# Malting and Distilling Facility RFP

Q&A  
2/15/2016

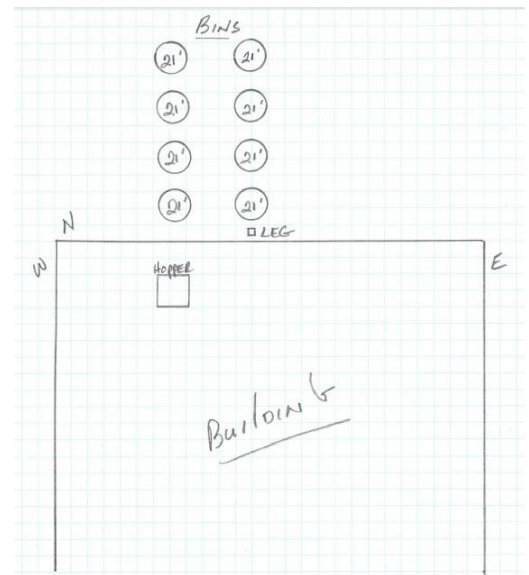
8. Q: Can the (8) 8,000 Bushels bins be installed per the attached drawing for better conveying flow and to save money on extra conveying equipment?

*A: This is a possible configuration for the bins. There are other possible configurations.*
